Technical Service Bulletin							
Date Issued	Model Year(s) Affected	Model(s) Affected			TSB #		
10/19/2006	3/24/05 – 2/17/06	All Spartan Chassis			266		
Brand					Type		
All	☒	American Star	☐	Mountain Aire	☐	All ☐ T T ☐	
		Dutch Star	☐	Kountry Aire	☐	F W ☐ C A ☐	
		Kountry Star	☐	Essex	☐	D P ☒ D B ☒	
Scottsdale	☐	Northern Star	☐	London Aire	☐		
☐ Air Conditioning & Heating ☐ Appliances & Accessories ☐ Cabinets & Furniture ☒ Chassis Components ☐ Construction Components ☒ Electrical Components ☐ Exterior Components ☐ Interior Components ☐ Plumbing & Bath Components ☐ Windows, Awnings, Vents, & Doors							
Description of Problem							
Brake lights and auxiliary brake become inoperative, and on certain engine applications the coolant level sensor and auxiliary brake "Brake Light Activation" cease to function; illuminating the "Check" engine light.							
Recommended Solution							
Perform wiring rework and install appropriate electrical components to relocate and control the brake light power source. See Manufactures attached repair directions and step by step procedures. Contact manufacture directly for additional information or instruction.

RSB06-520-001A

RECALL SERVICE BULLETI

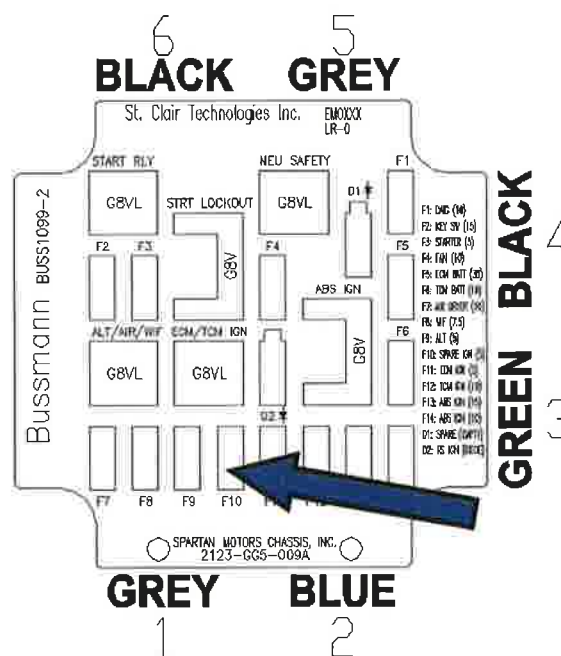
9. Contain the harness relays along with the excess harness and connectors with tie wraps or equivalent.

Note: Wires must be directed downward.

Note: Ensure any harnesses and hoses previously cut loose in step 2 are contained.

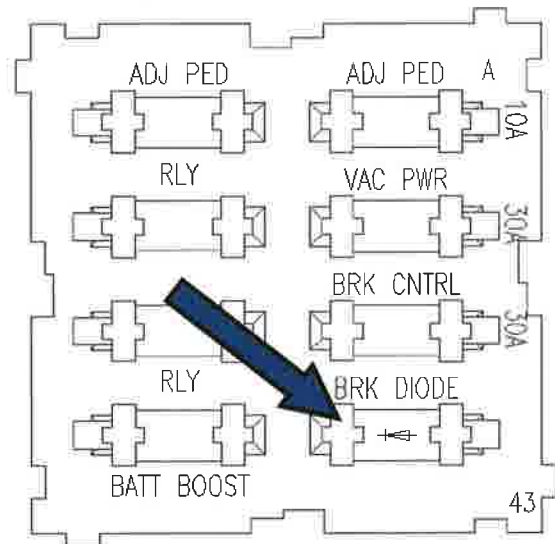
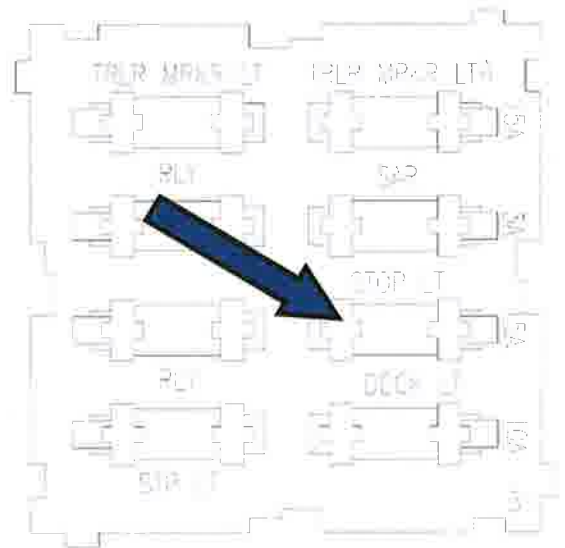
11. Verify and/or replace the STOP LT fuse located in the front PDC with a 15A fuse or 15A circuit breaker (determined by the kit being used).

The front PDC is located at the left front corner of the vehicle just forward of the front wheel in an outside compartment. The STOP LT fuse is located near the top center of the front PDC.

12. REPLACE the BRK DIODE. This diode is located in approximately the center of the front PDC.

Note: Although the diode may still function and have no apparent defects, it may have internal damage.

Note: Diode must be keyed correctly as shown.

FIG. 6-1

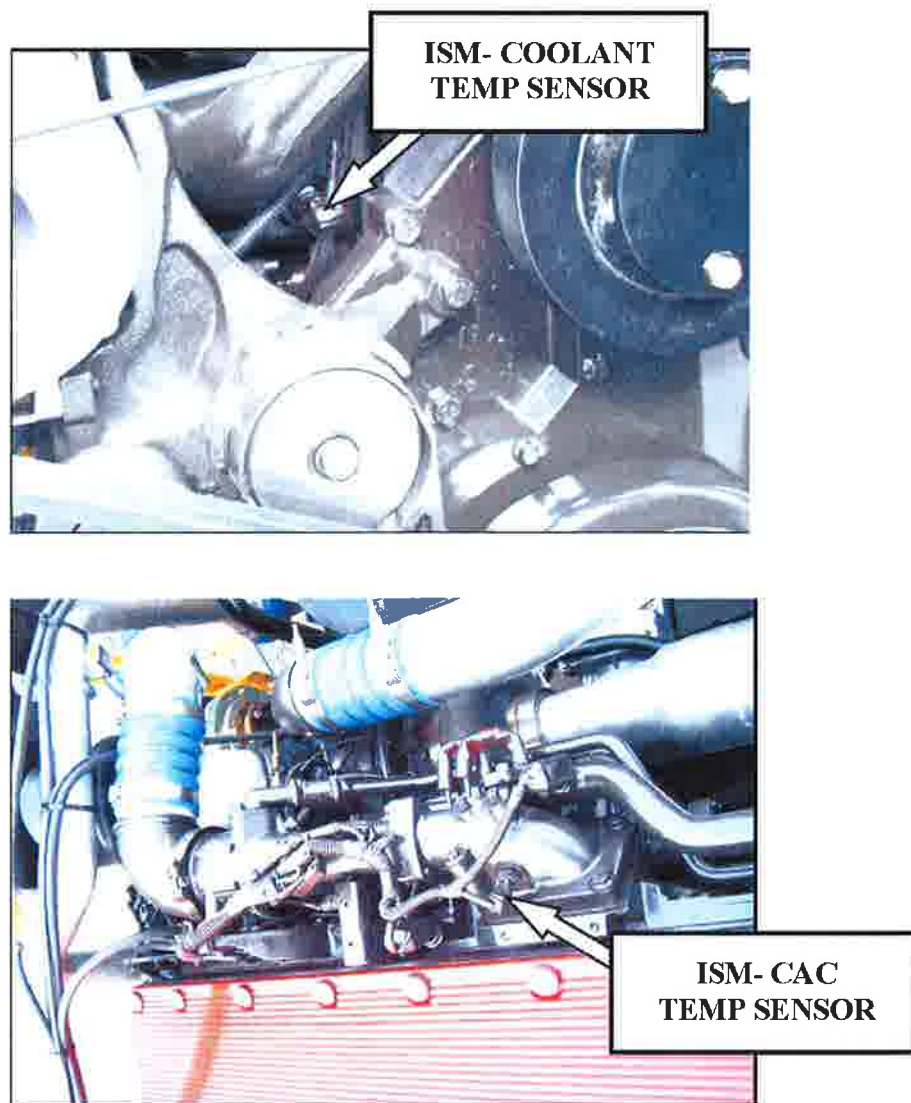
- e) Cooling fan operation for ISM and ISX engine by unplugging either the cooling temperature sensor or the CAC temperature sensor on the engine.

Refer to FIG. 6-1 for ISM temp sensor locations and FIG. 7-1 for ISX temp sensor locations. When either sensor is unplugged, the fan clutch automatically engages. When the sensor is plugged back in, the fan clutch disengages.
